Item #13C:
Village Trustee Marshall
Three Lake Drive Storm Sewer Culvert - Update

Subject: Water Conveyance Modification/Pond Sediment Removal

Re: The Lakes of Long Grove Outlet Structure Investigation

Profile View

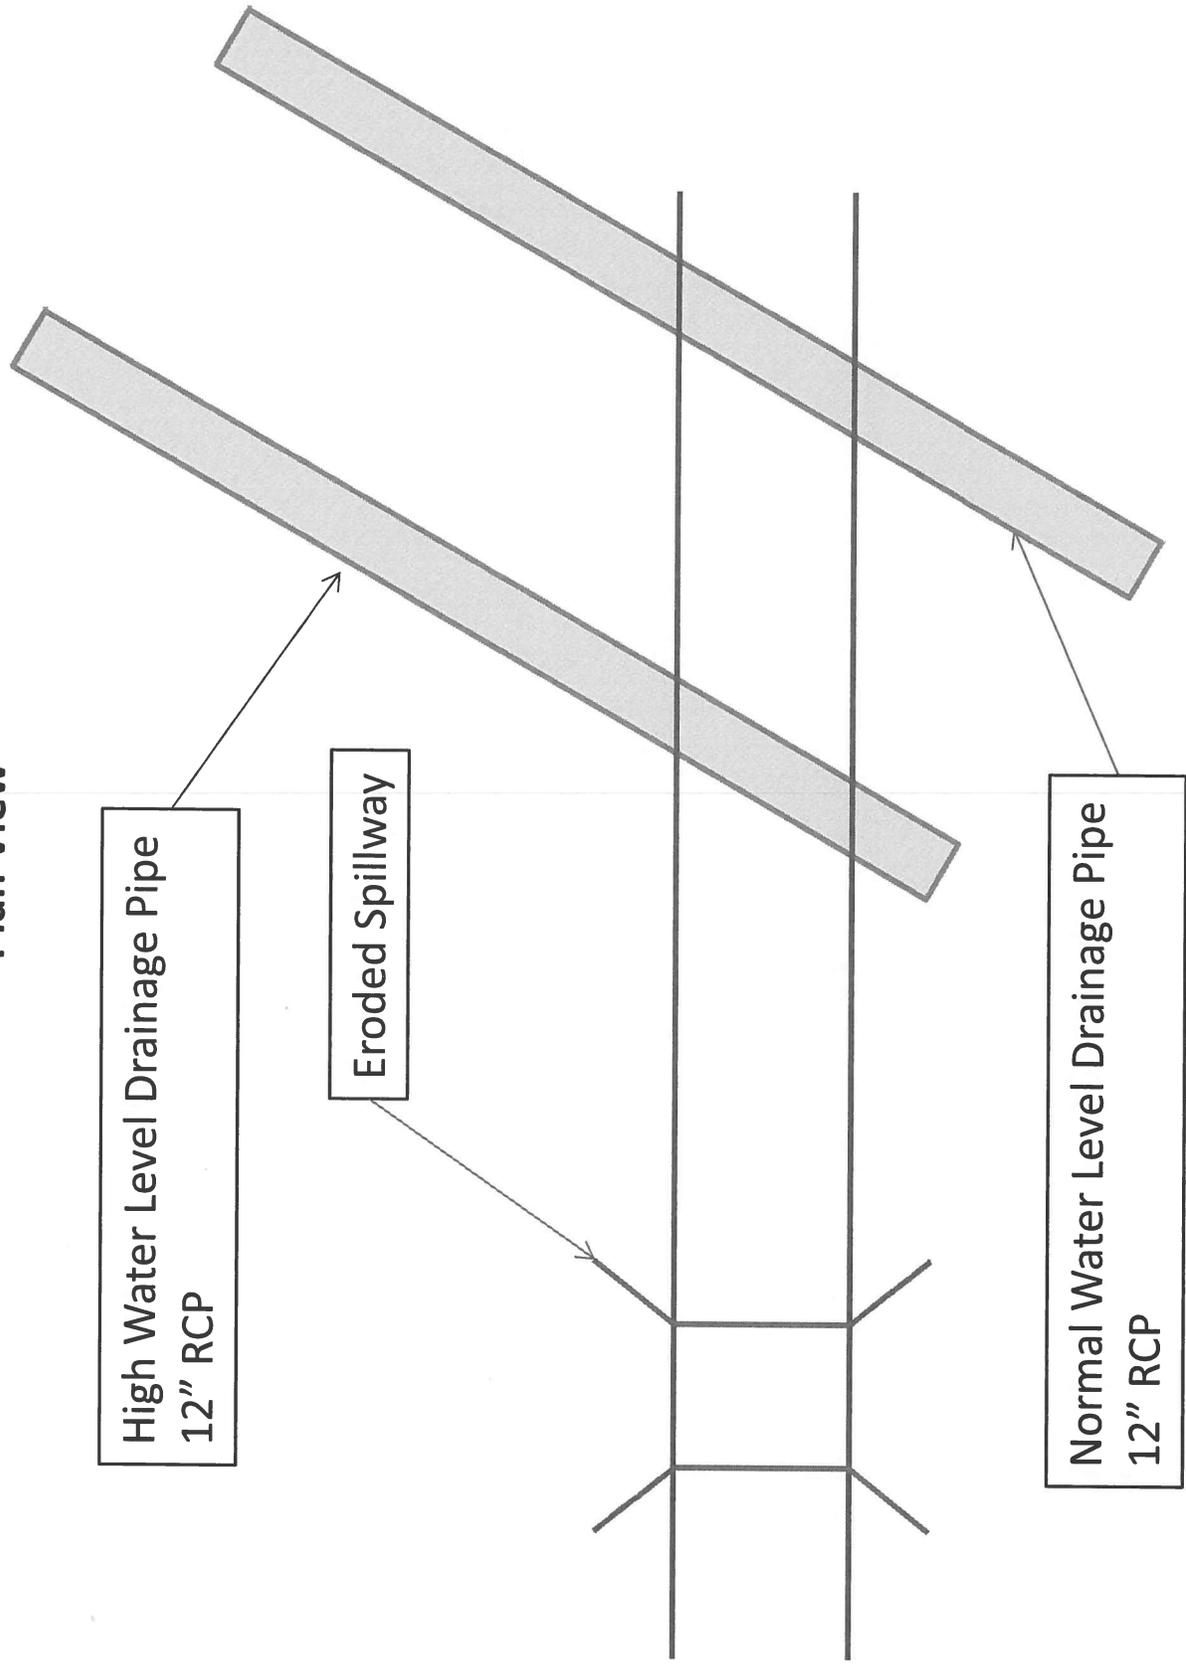
Levee/Berm Condition – The levee, or berm on the north end of the East Basin is in poor to very poor condition. Seepage was evident along the entire base of the berm. Woody vegetation and trees were observed to be growing on top of and on the embankments. Numerous animal burrows were observed in the berm. Approximately halfway along the top of the berm, an eroded spillway was observed. The spillway did not appear to be a designed structure; rather, it appeared to have formed over time as a result of erosion along the top of the berm. A photo of the eroded spillway is included as Exhibit B. The water level on March 31, 2014 was very near the top of the berm. The eroded spillway was serving as the primary water control structure.

High Water Level Drainage – The Record Drawings show a concrete weir detail as the proposed high water overflow structure. During our site visit, a weir structure was not observed. Instead, an approximately 12-inch reinforced concrete pipe at the estimated high water level was identified. The inlet of the pipe was not protected with a grate, and was plugged with woody debris and leaves. A photograph of the high water level drainage inlet is included as Exhibit C. The outlet of the high water level drainage pipe did not have an outfall apron. While inspecting the outlet of the pipe it was observed that water was seeping around the outside of the pipe, and was not flowing through the inside of the pipe. When debris was manually cleared from the pipe inlet, water began draining freely through the high water level drainage pipe, indicating that this pipe is not plugged internally.

Normal Water Level Drainage – A second, approximately 12-inch reinforced concrete pipe that appeared to be the primary NWL outlet structure was observed approximately 50-feet east of the high water level drainage pipe. There was no drainage present inside, or along the outside of this pipe. The spillway apron at the base of the pipe had been pulled away from the rest of the pipe by approximately 3-inches. A photograph of the outlet of the NWL pipe is included as Exhibit D. Based on the notes on the Record Drawing, the inlet of the NWL outlet pipe is approximately 4.5-feet below the current water surface.

High Water Level Drainage Pipe
12" RCP

Eroded Spillway

Normal Water Level Drainage Pipe
12" RCP

Once the location of the NWL drain blockage is known, repair work can begin. If the blockage is determined to be beneath the water, and the pipe is in good condition, ILM proposes that an excavator be brought in to try breaking off the plugged area of the pipe in the water, allowing water to gain entry into the pipe. The excavator would work to clear debris from the pipe until the water level reaches the NWL. Once the NWL is achieved, the broken pipe would be repaired, and a grated inlet structure would be installed. The existing eroded spillway would be repaired with gravel, clay, and geotextile, to prevent further erosion.

If the camera investigation indicates that the pipe is in poor condition, or the plug is within the berm, the effort to repair the drainage outlet is significantly increased. Pumps will be necessary to drain the lake down to, or below the NWL. Once the water level is at or below the NWL, the existing drain pipe can be excavated out of the berm, and a new drain pipe, inlet, and outfall apron can be installed. The existing eroded spillway would be repaired with gravel, clay, and geotextile, to prevent further erosion. The cost of this repair work is not known at this time due to the potential permitting, design, and construction uncertainties.
